**PIMA COUNTY
PROCUREMENT DEPARTMENT
DESIGN AND CONSTRUCTION DIVISION**
130 W. CONGRESS STREET, 3rd FLOOR. ☞ TUCSON, AZ. 85701
PHONE: (520) 724-3731 FAX: (520) 724-4434

ADDENDUM No. 1

PROJECT: Tangerine Landfill Final Closure Plan

SOLICITATION NO.: IFB 198029

SHEET NO. 3
PROJECT NO. 15068

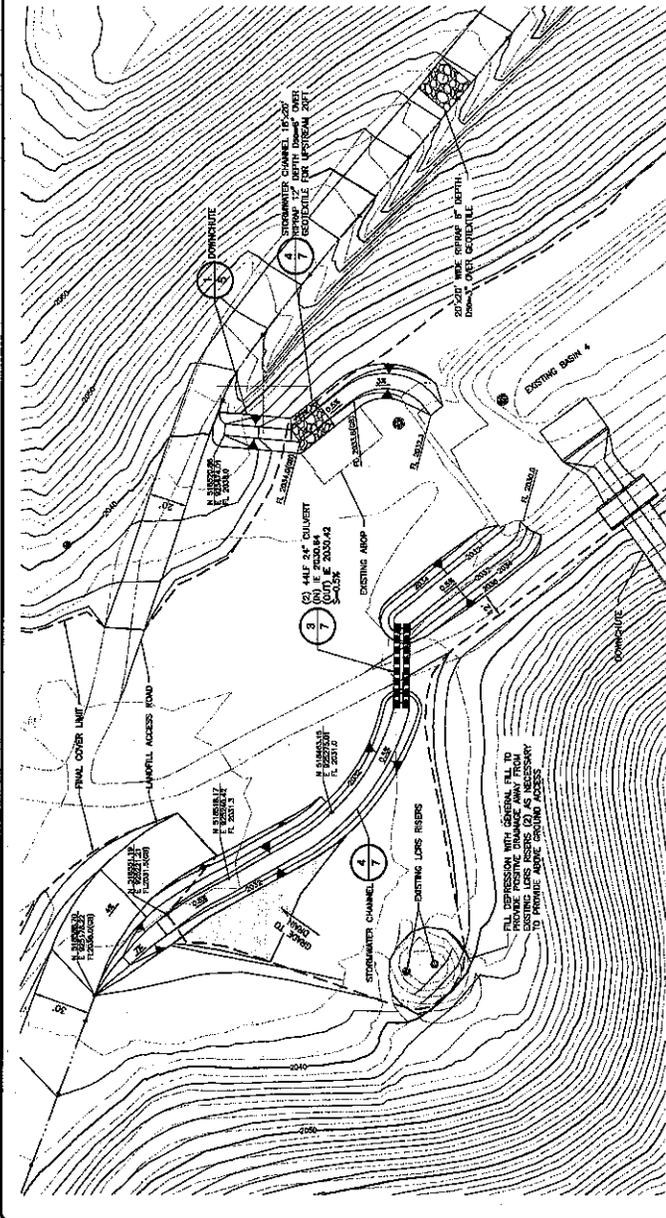
REPLACE: Sheets 3 & 7 in Tangerine Landfill Closure Plans package with the Sheets 3 & 7 attached to this Addendum.
